DOMETIC HEATING FURNACES

EN Furnace Limit Switch Service Bulletin

Model	Serial Number Range
All Small & Medium Furnaces (AFS, AFM, DFS, DFM)	73985322 – 81099541

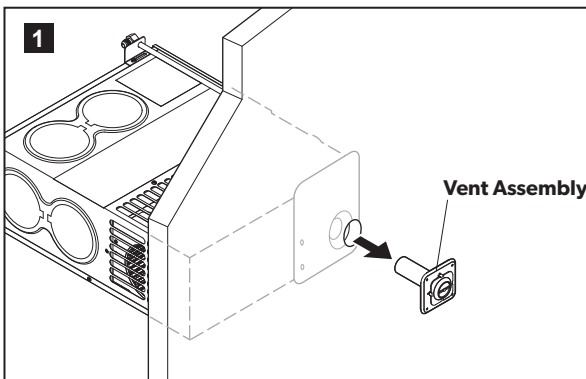
The cause of this nuisance issue is a mistaken omission of a plastic wire tie to suspend the heat exchanger limit switch wires up and away from the exhaust tube vent terminal. The omission of this component allows the limit switch wires to potentially melt on the vent terminal, shorting to ground, and causing either the fuse or circuit breaker in the circuit to blow, or the sail switch to become inoperative. **In ALL cases the safety devices in the system are performing as designed and prevent the furnace from operating.**

Dometic recognizes this nuisance tripping issue is an inconvenience to our OE and potential end-use customers and we apologize for the extra work that may result. In an effort to try and reduce the amount of work required to correct this mistake we have designed and tested a field repair for this occurrence which will be more expensive for Dometic but will make the field repair much easier. The repair will consist of sliding a 6" long, high-temperature rated, fiberglass sleeve over the exhaust tube after removal of the vent assembly. The field repair kit will be available within March, 2018. The field repair kit part # is 31389, Flat Rate Time is .5 and the fault code is 617.25.
